ADDENDUM NUMBER 1

MILWAUKEE COUNTY ZOOLOGICAL GARDENS  
WINTER QUARTERS ROOF AND ASPHALT DRIVEWAY REPLACEMENT  
Site #355, Bldg. #4670  
10001 West Blue Mound Road  
Milwaukee, WI 53226

Project Number: Z063-09478

Date of Addendum: June 7, 2013

SK1

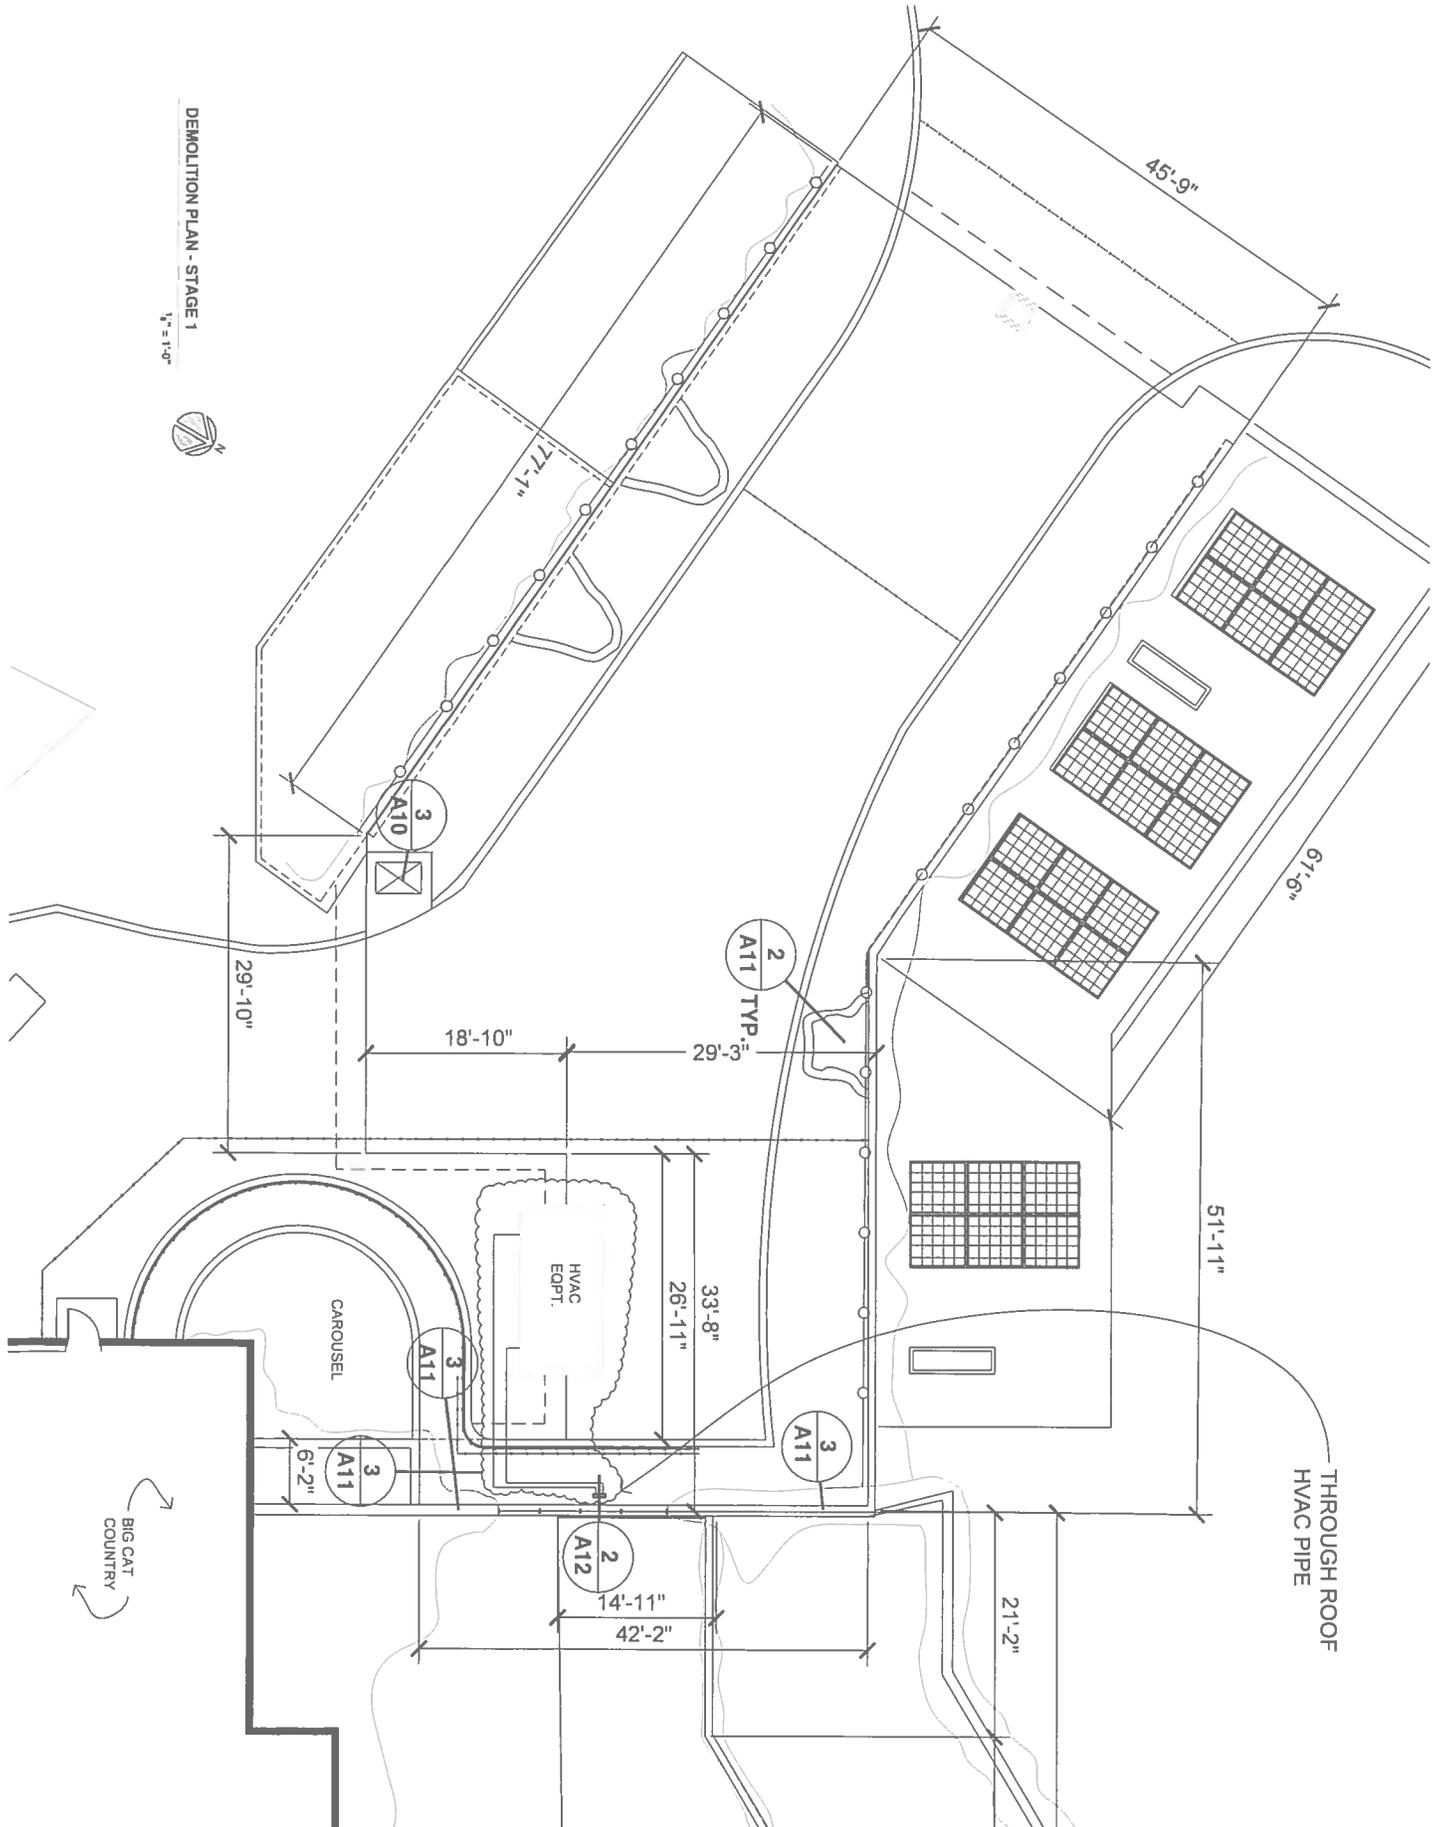
Sheet A2, A3, A4

1. Apply reference dimensions and other information shown on drawing sketch SK1 attached to this addendum to original drawing sheets A2, A3, and A4.

SK2

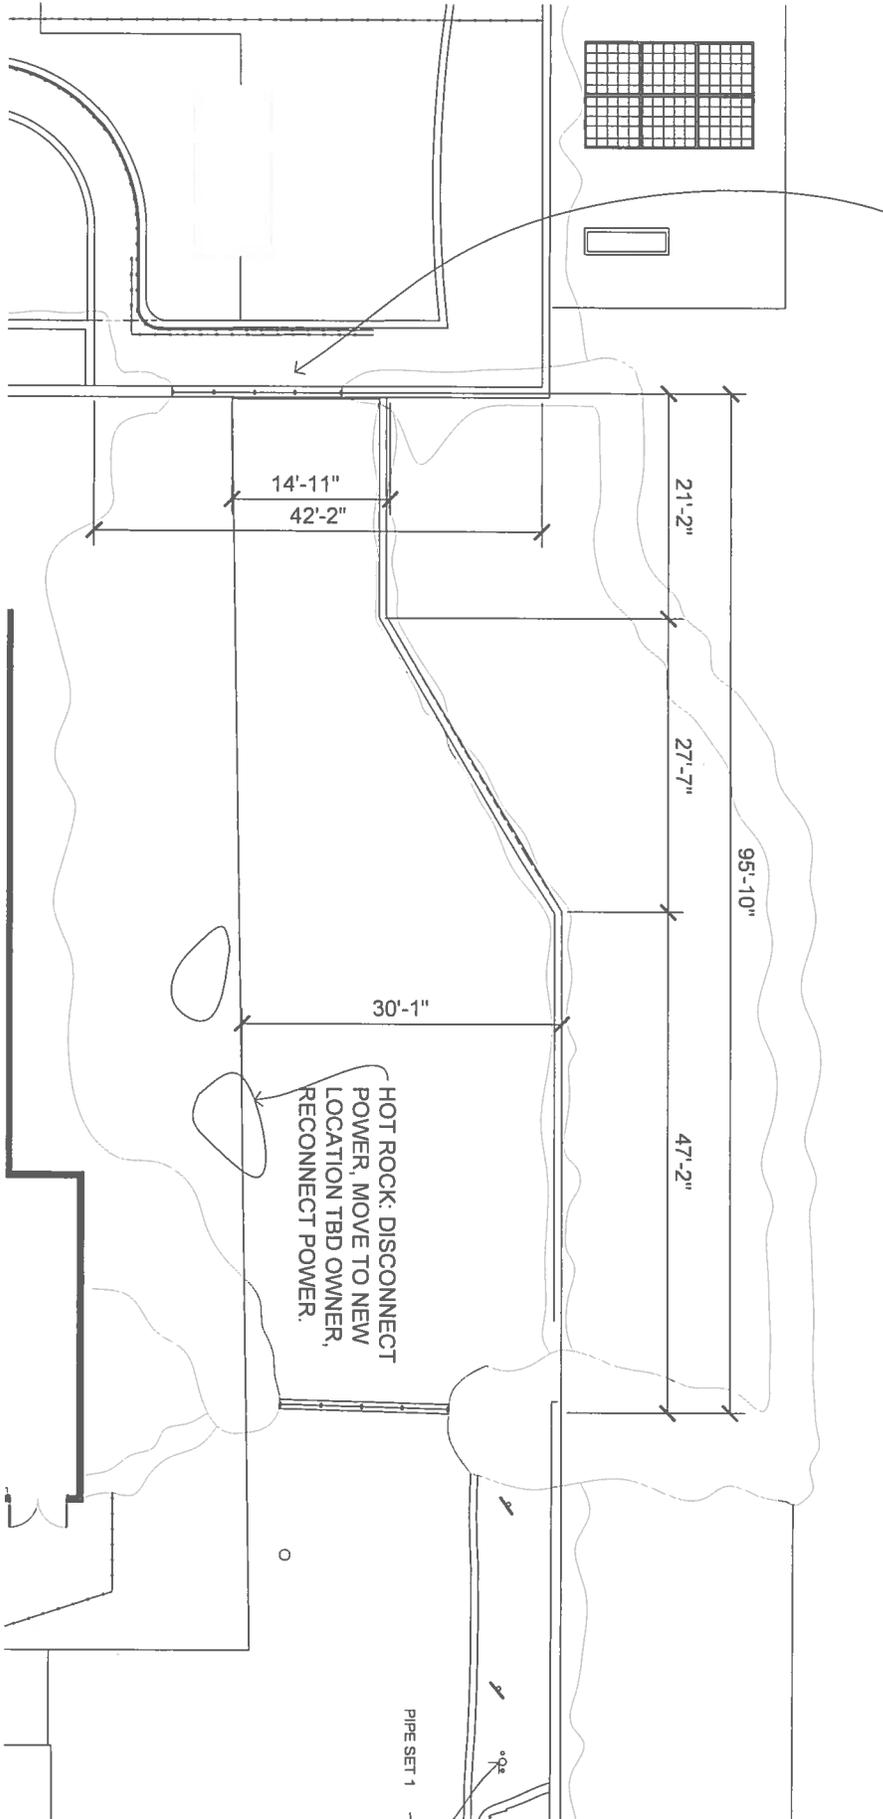
Sheet A5, A6

1. Apply reference dimensions and other information shown on drawing sketch SK2 attached to this addendum to original drawing sheets A5 and A6.

SK3

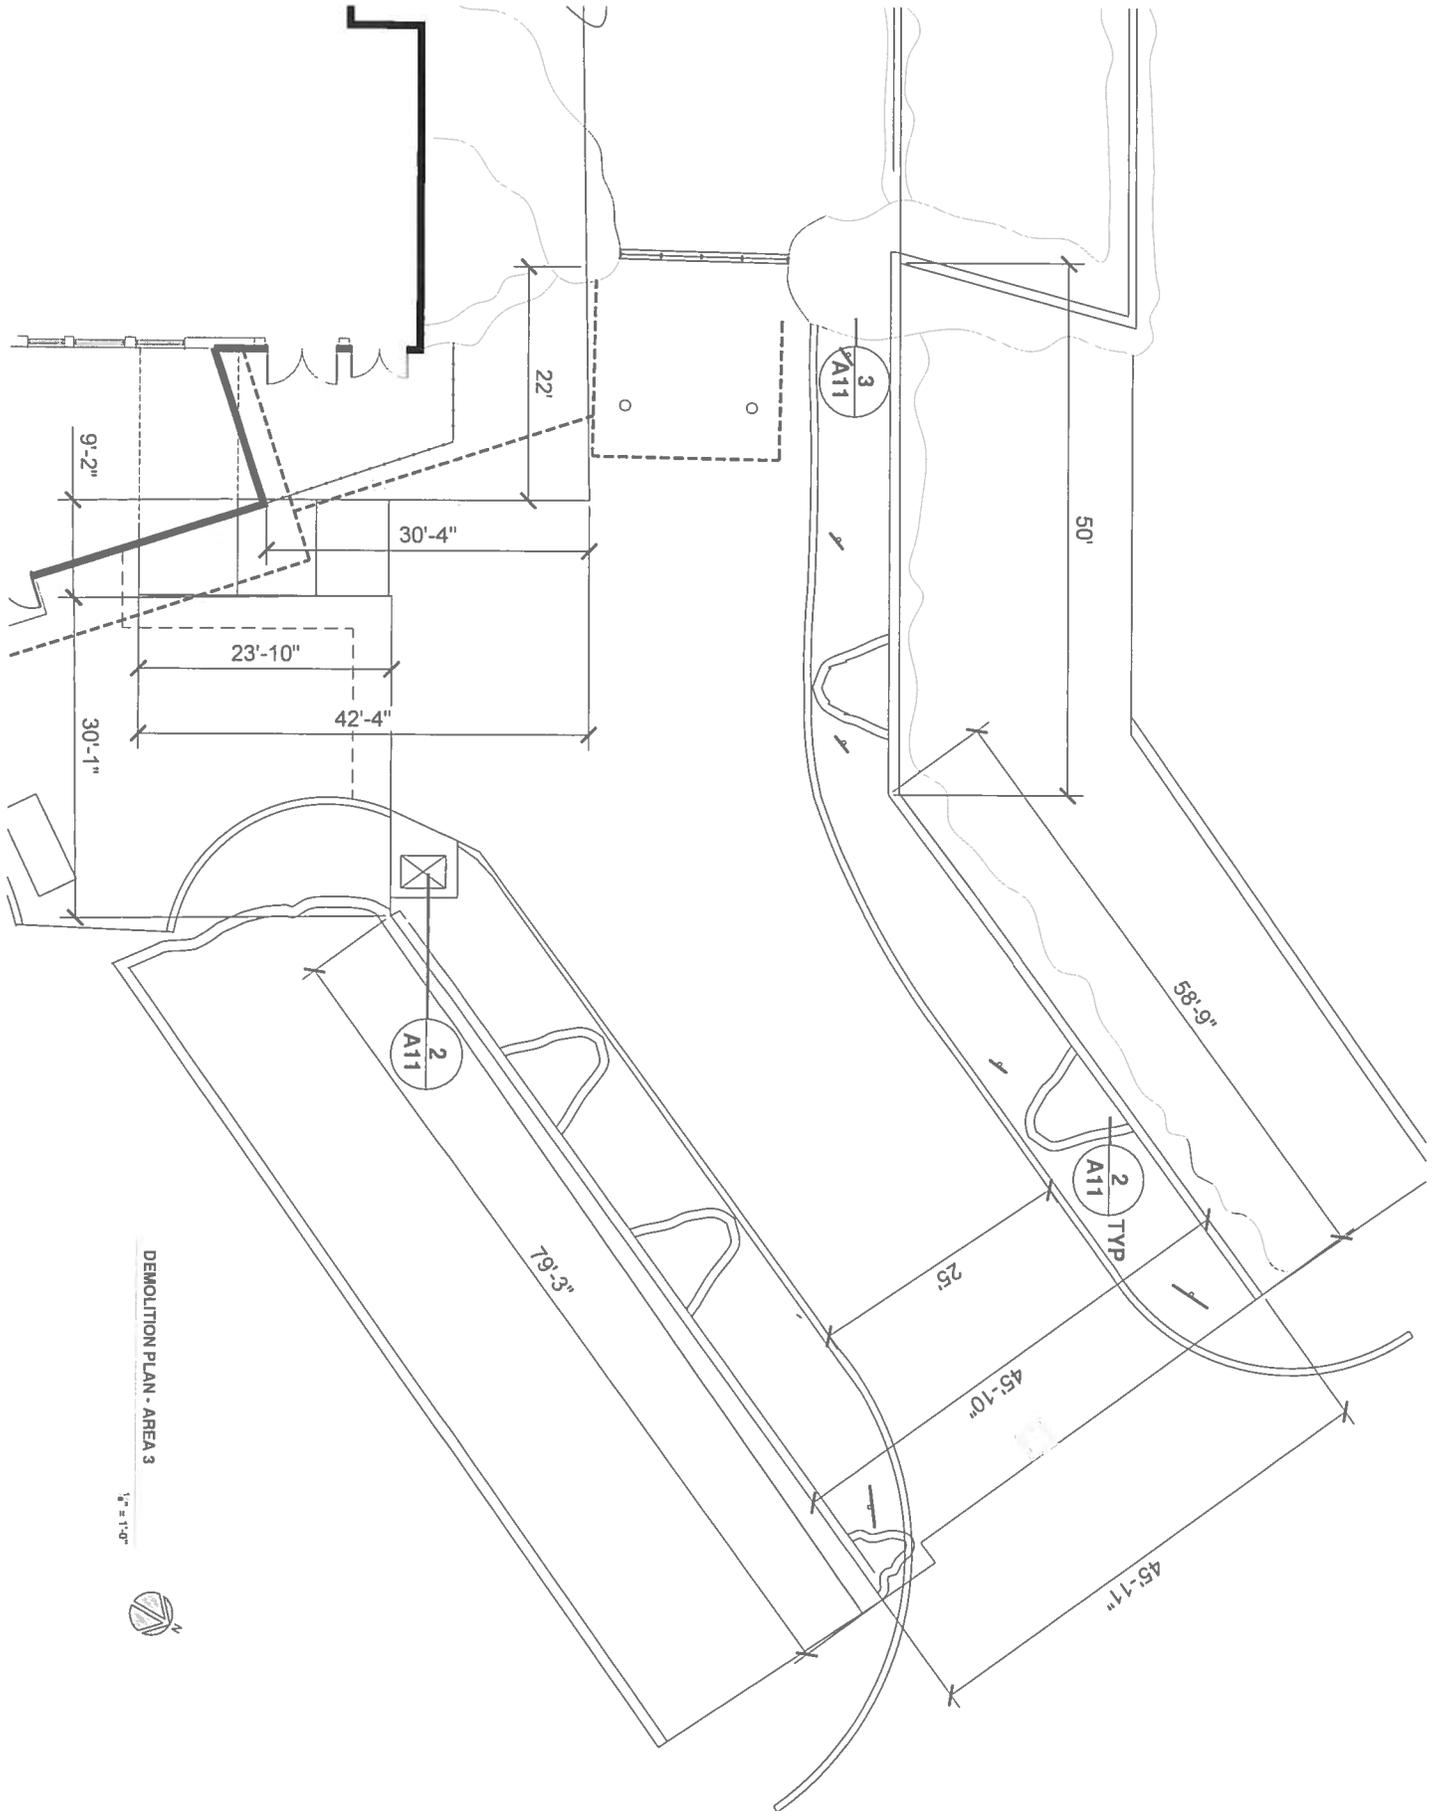
Sheet A7, A8, A9

1. Apply reference dimensions and other information shown on drawing sketch SK3 attached to this addendum to original drawing sheets A7, A8 and A9.
